TCEP Project No.: 097-039-15
LPS Bid No.: 8365

ADDENDUM NO. 2

LPS Humann Elementary Renovation
6720 Rockwood Ln.
Lincoln, NE 68516
TCEP No.: 097-039-15
February 5, 2016

FIRST FLOOR POWER & AUXILIARY SYSTEMS PLAN - AREA 'A'
 SCALE: 1/8" = 1'-0"

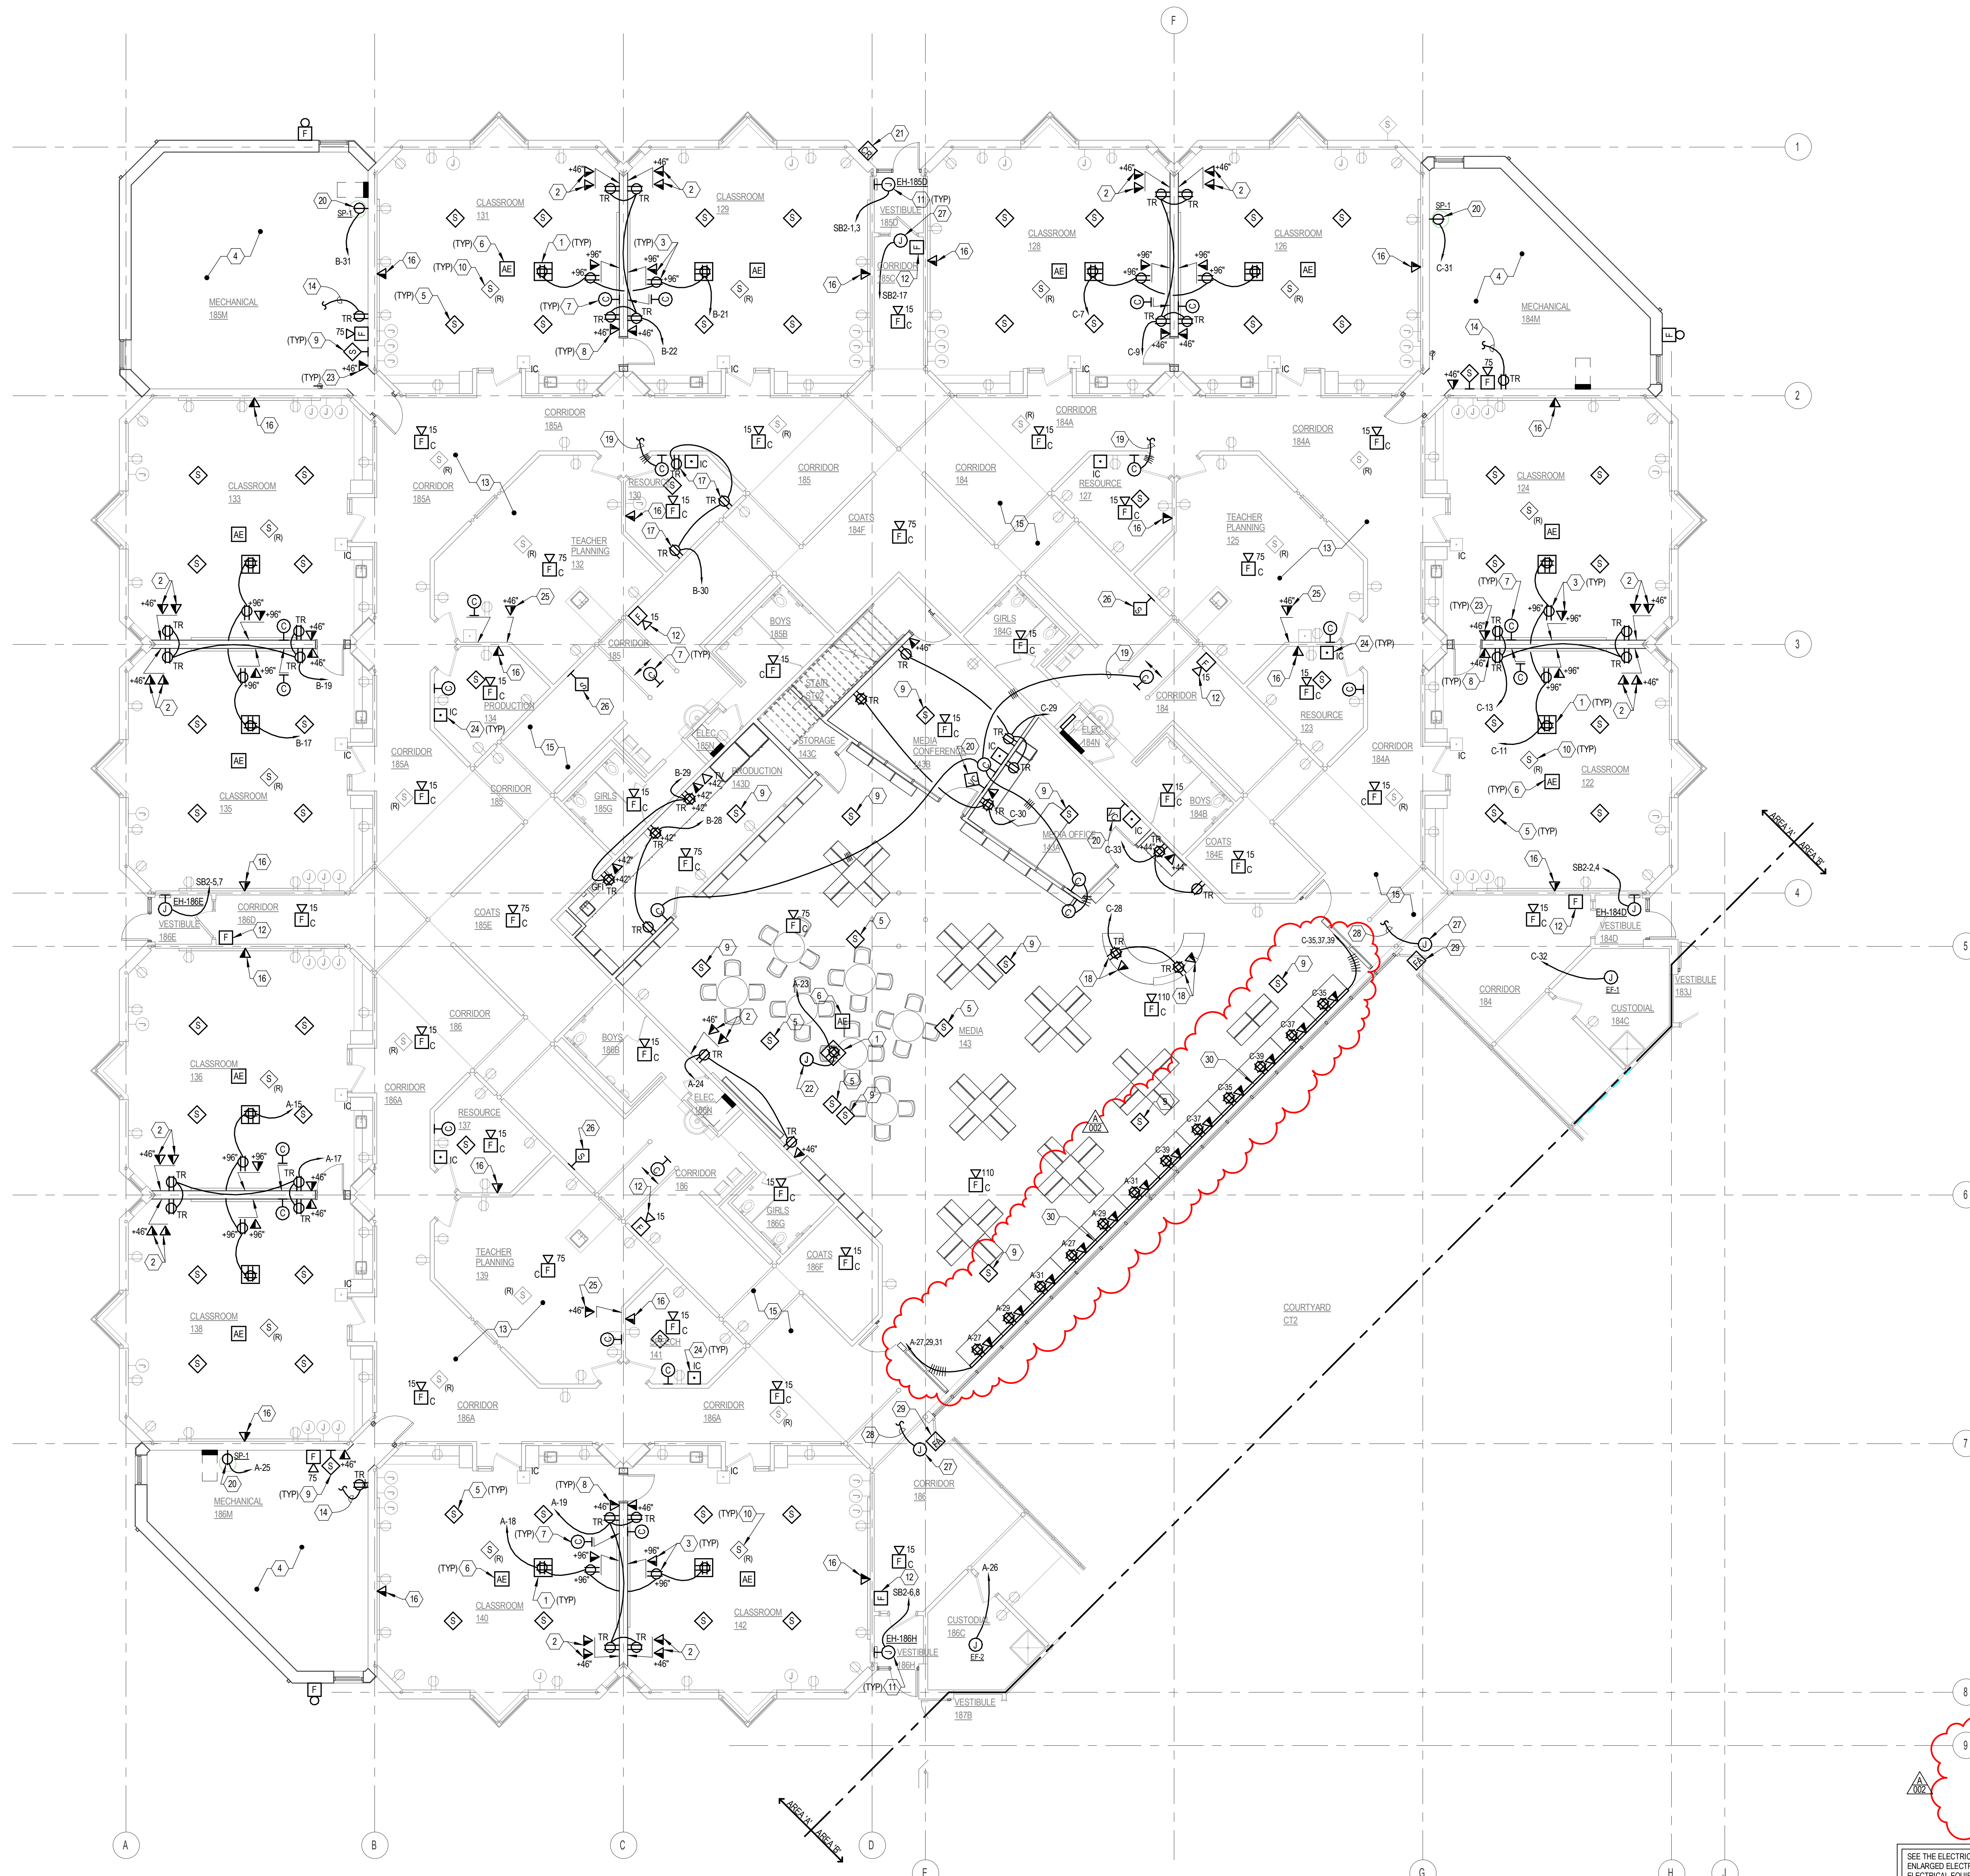
See the attached revised sheet E2.11A for the addition of wiremold in the Media Center.

FIRST FLOOR TELECOMMUNICATIONS PLAN - AREA 'A'
 SCALE: 1/8" = 1'-0"

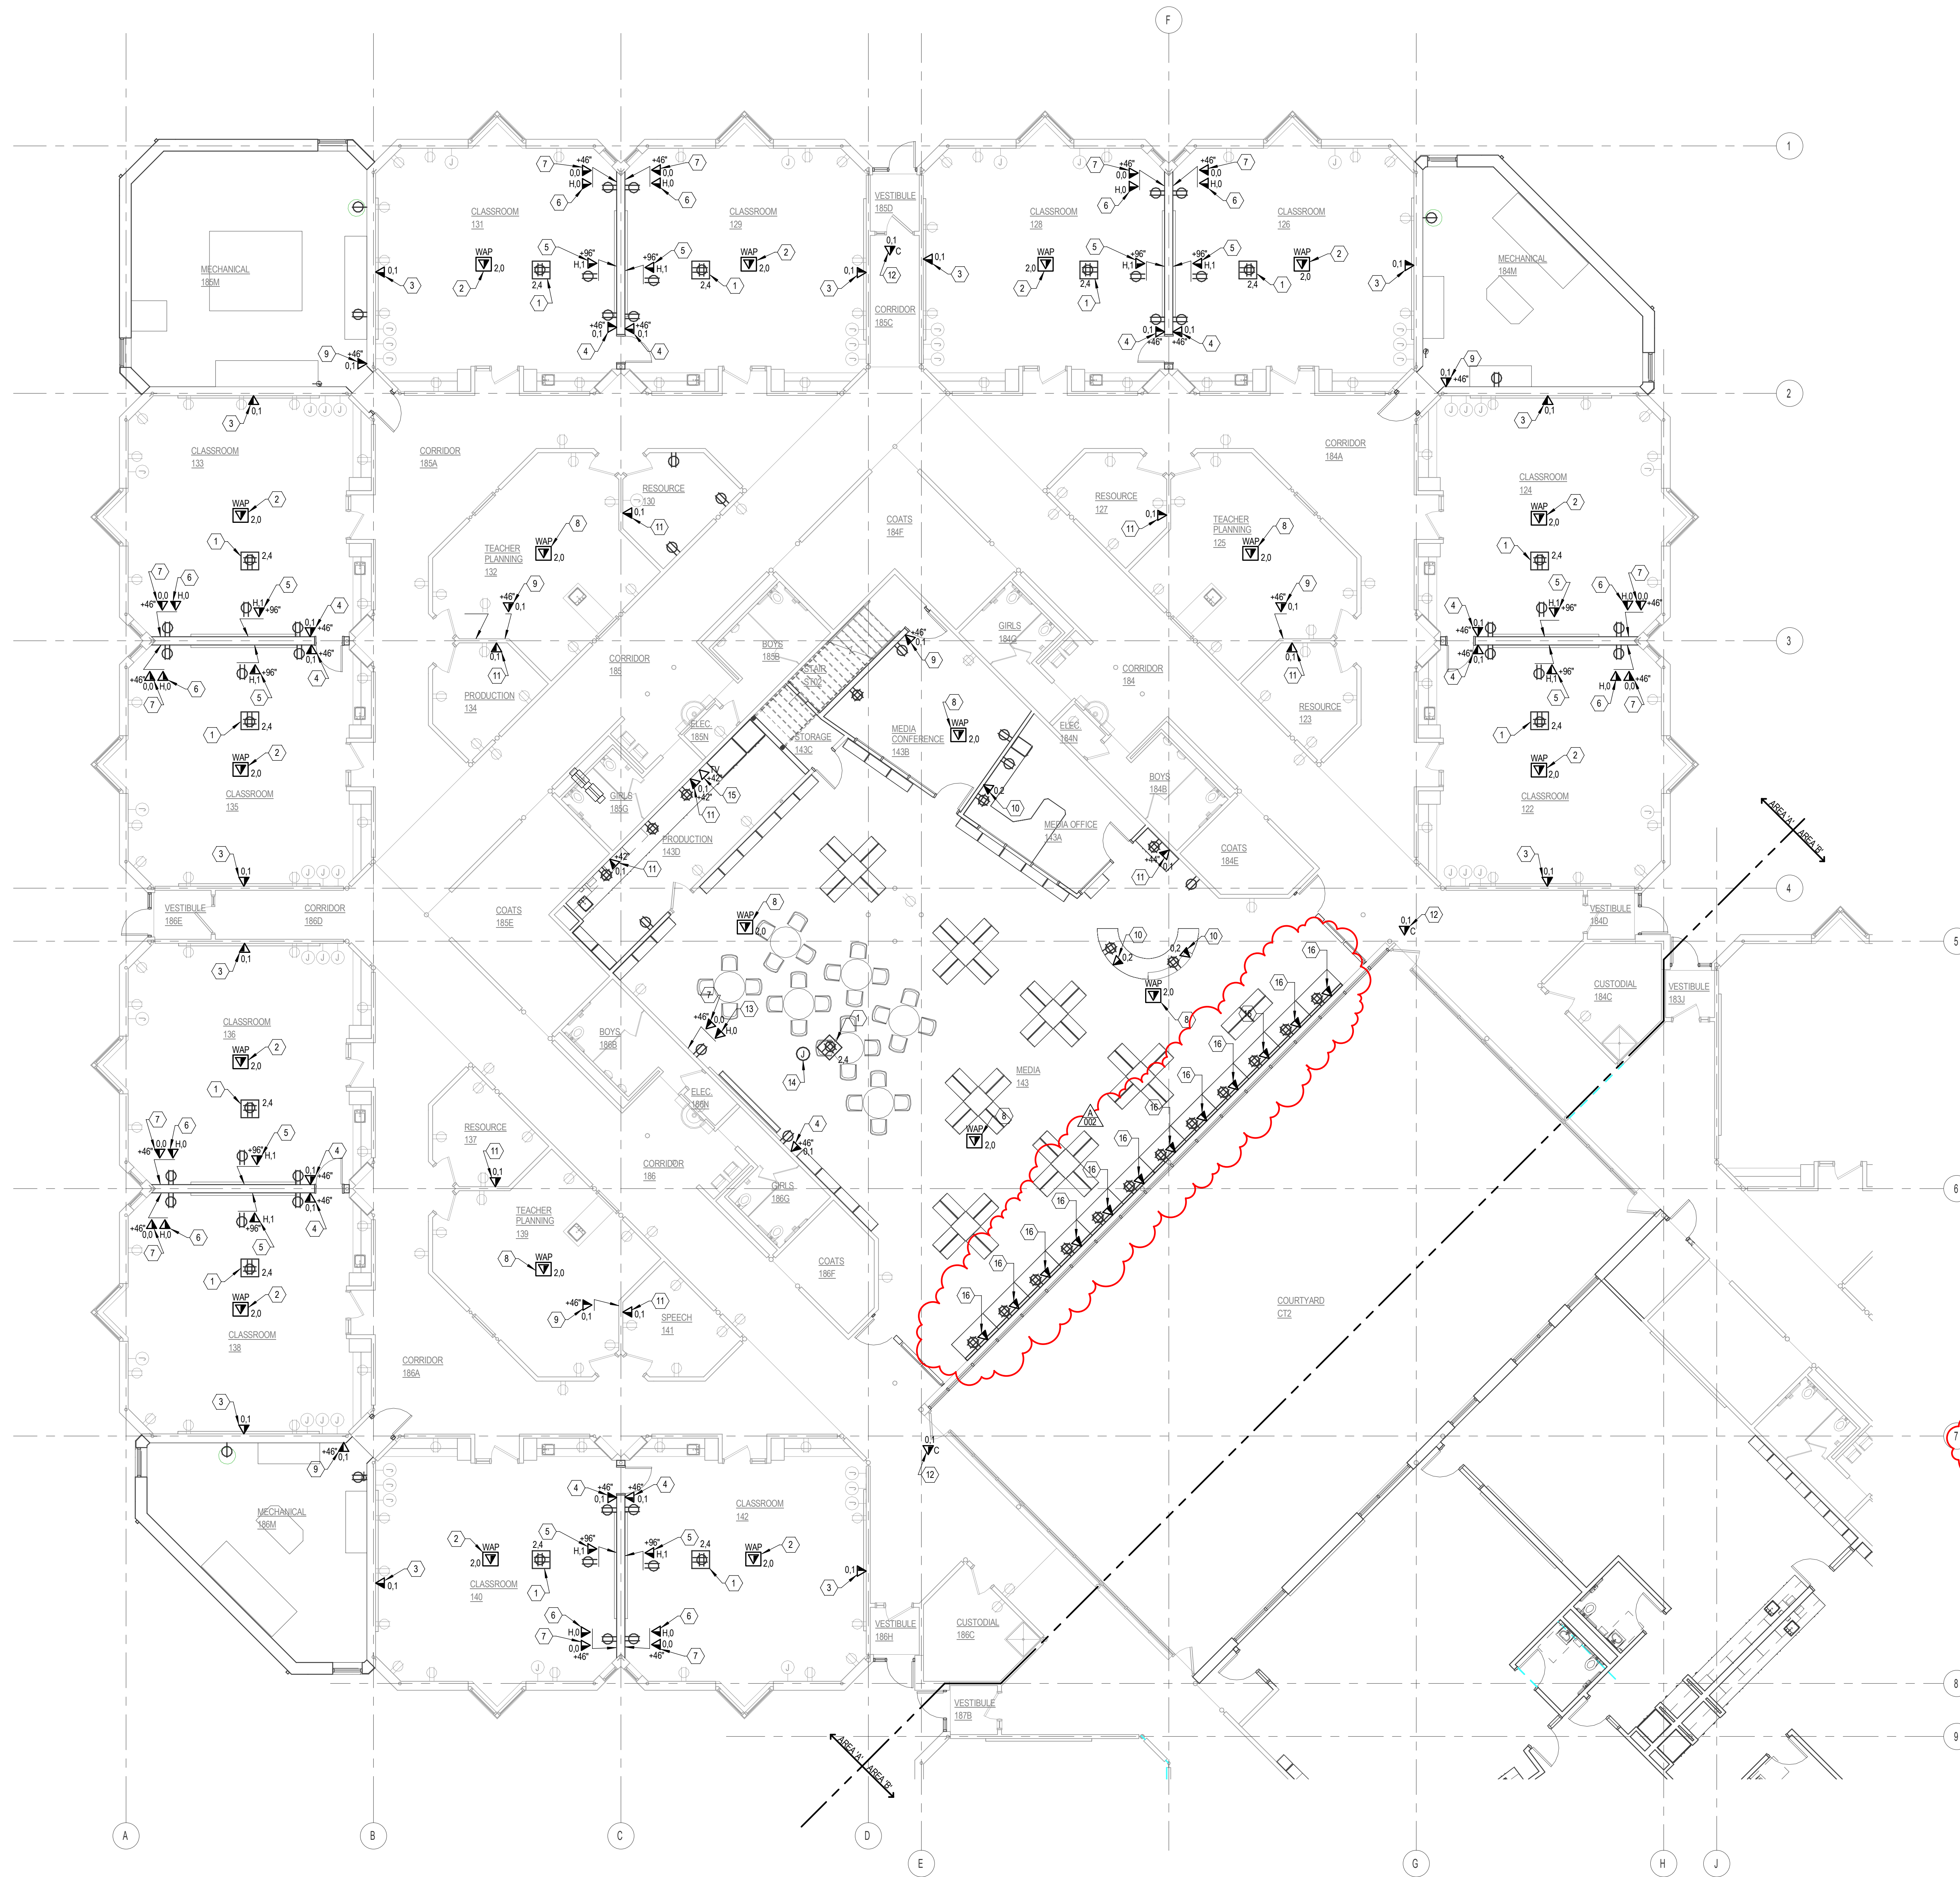
See the attached revised sheet T1.11A for the addition of cabling to the wiremold in the Media Center.
